GATE / DRAIN BIAS VOLTAGE DACS

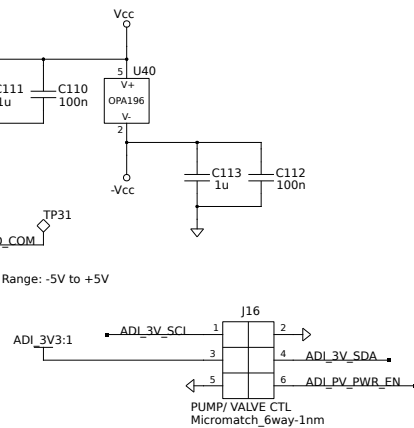
DAC8831: 16 bit DAC
O/P: -VREF to +VREF
TEST: 10uF Tanatalum required?
or 10 uF Ceramic sufficient.
Power Supply: w/o Filter
with 5V linear Regulator

DUAL RAIL POWER SUPPLY

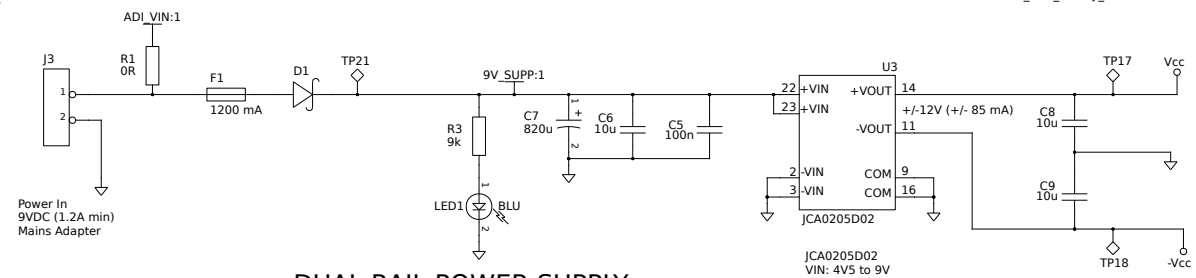
REVIEW:
Consider reducing opamp supply rail voltages considering that bias voltages now only need to go up to $\pm 5V$.
